Presentation to Causeway Coast & Glens Council	
Proposal:	Brishey Wind Farm
Reference:	LA01/2023/0008/F
Item:	5.1
Date:	26 August 2026
Name:	Catriona McReynolds and Nodlaig Ní Bhrollaigh On behalf of Save Benbradagh Group
	Objection

Comments regarding Proposed Turbines Elevation Drawing

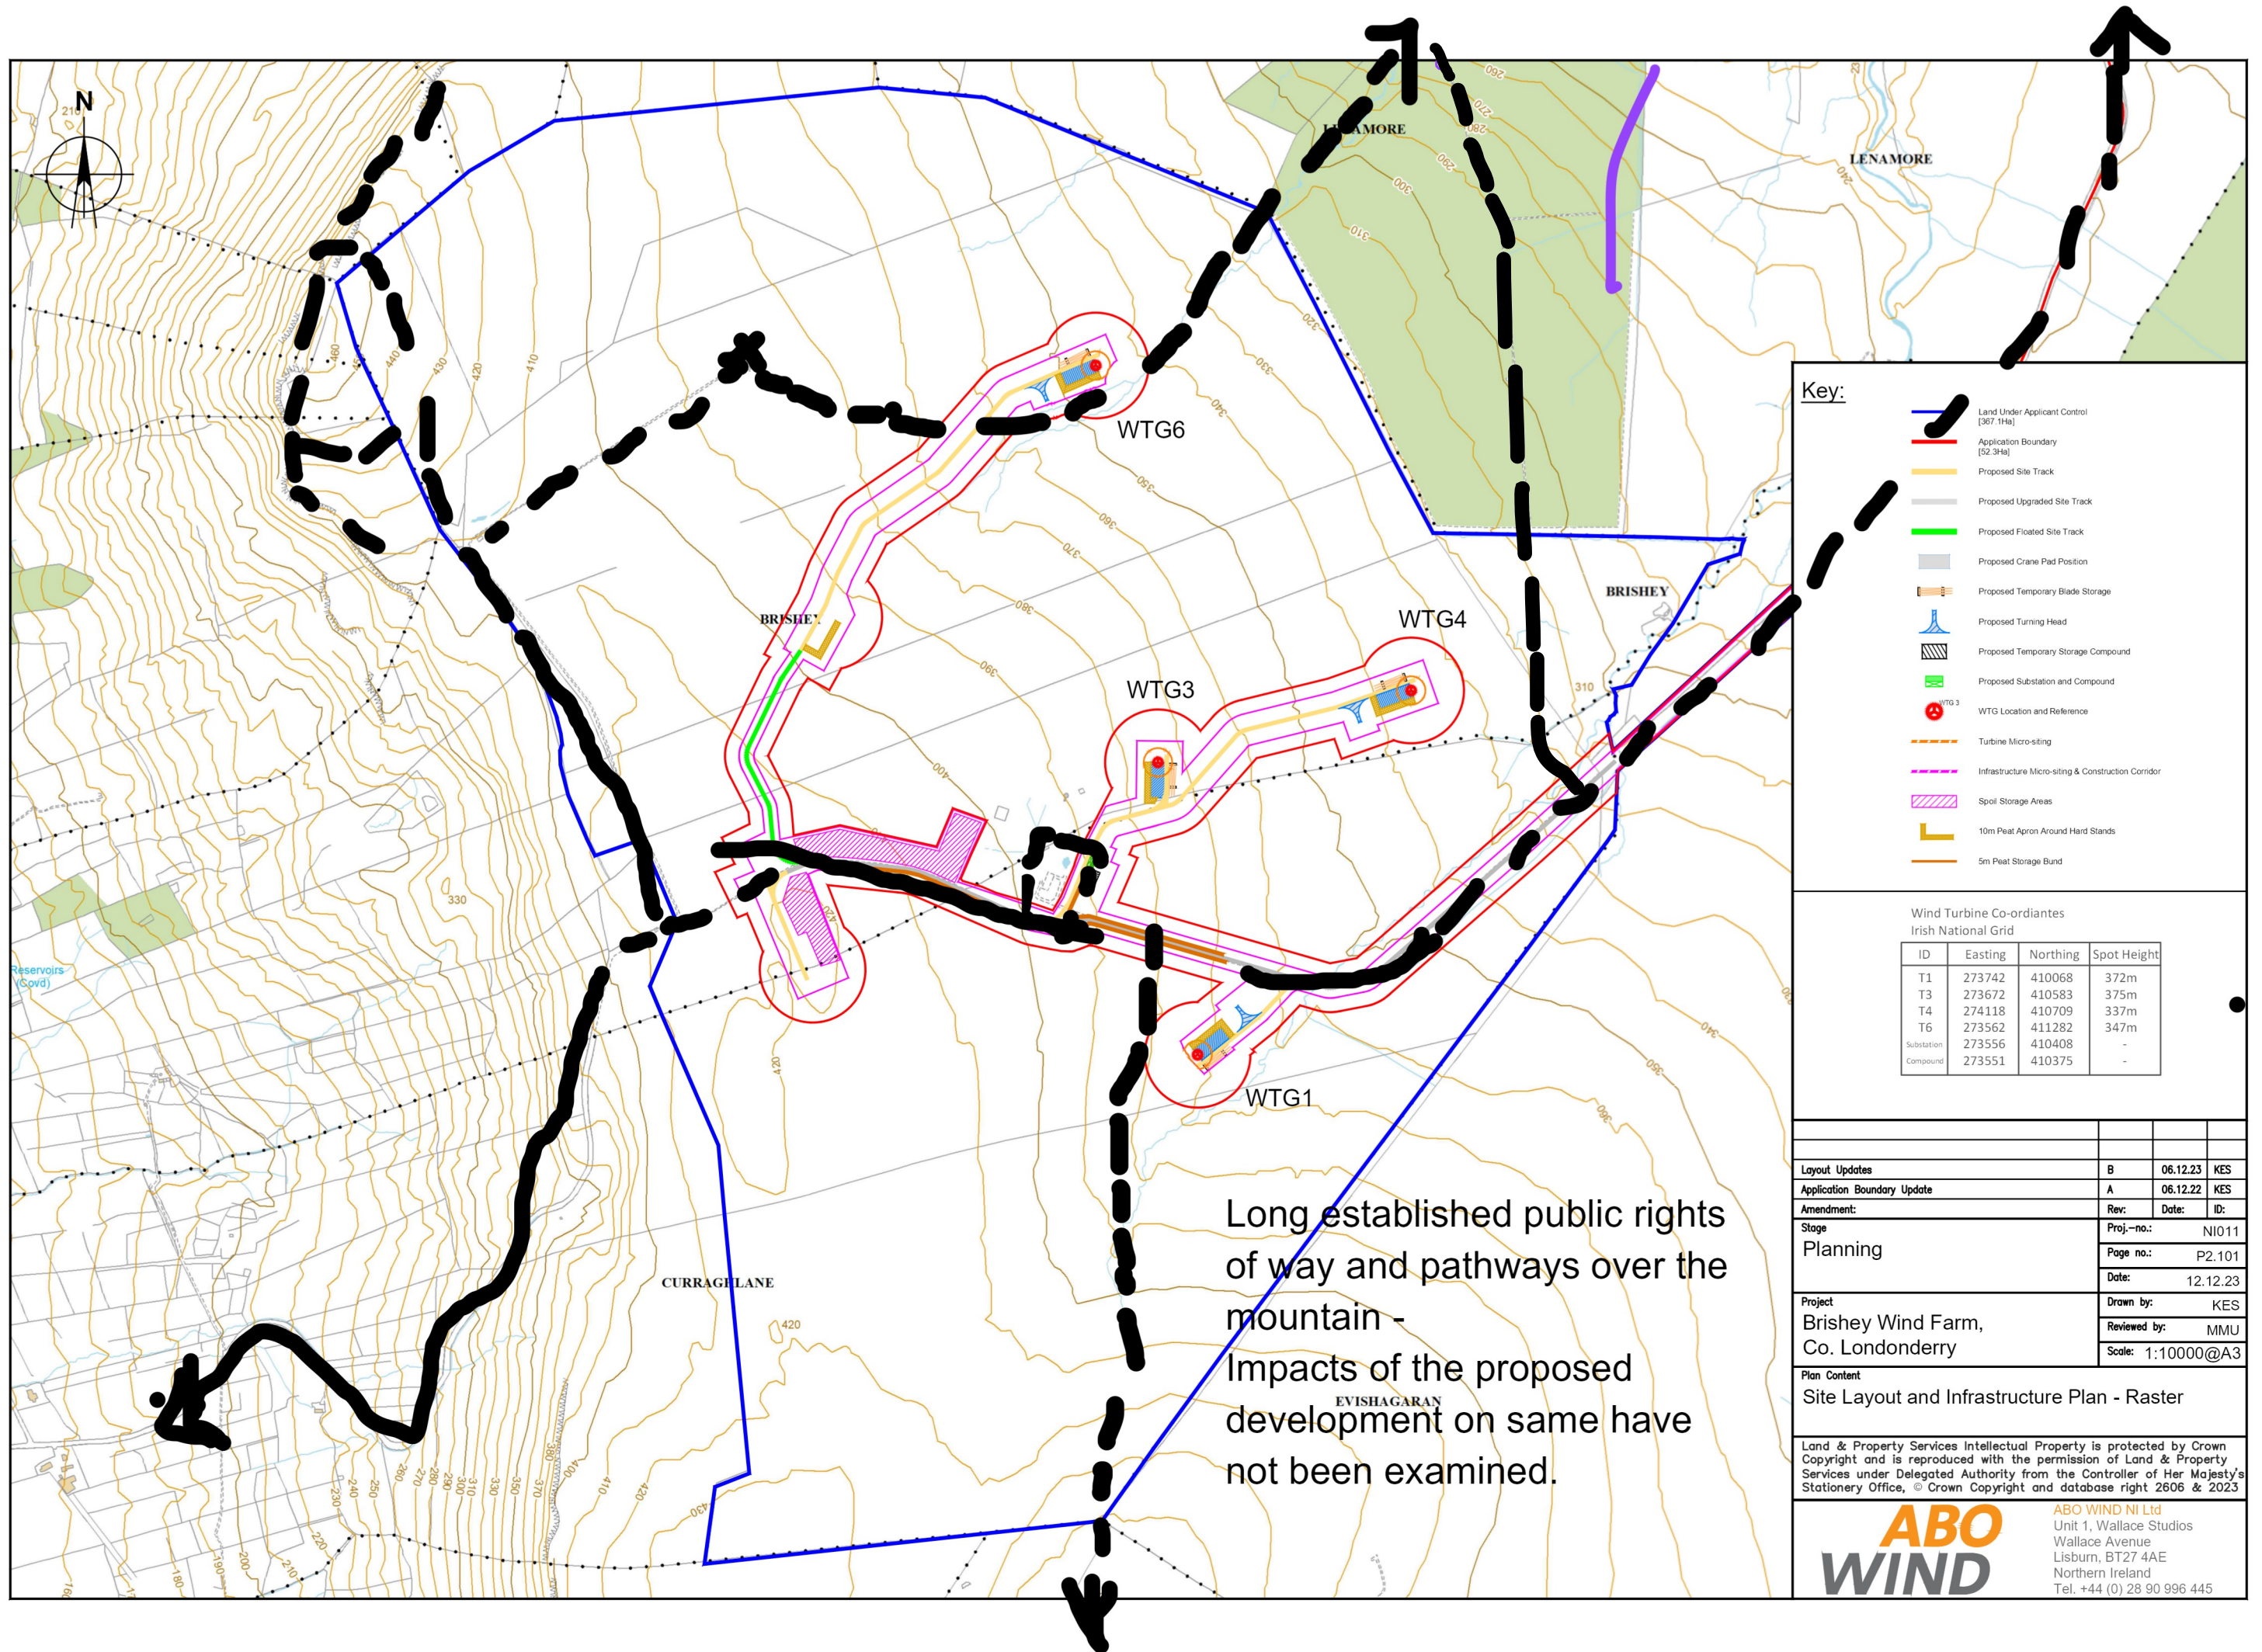
The proposed turbines are detailed as being overall height 150m to the tip and having rotor diameters of between 115m – 136m.

Examining a 136m rotor diameter

136m rotor diameter means the turbine blade clears the ground by only 14m – ie. 9.3% of the total turbine height.

The elevation drawing tabled does not convey this – the drawing and diagrams are very clearly inaccurate and underplay the width, ground clearance, and true impact of the proposed development, and create confusion and undermine the public's understanding of scale of the proposal.

Examining a 115m rotor diameter

115m rotor diameter means the turbine blade clears the ground by 35m – ie. 23% of the total turbine height.

Again the elevation drawing tabled does not convey this – the drawing and diagrams are very clearly inaccurate and underplay the width, ground clearance, and true impact of the proposed development, and create confusion and undermine the public's understanding of scale of the proposal.

- ROTOR 136M ROTOR DIA. (CLEARS GROUND BY ~~14M~~)
- RED OVERMARK SHOWS TRUE SCALE.

- DIAGRAMATIC ELEVATIONS GIVE VERY INACCURATE PORTRAYAL OF PROPOSAL & CREATE CONFUSION AMONGST PUBLIC AS TO SCALE OF DEVELOPMENT.
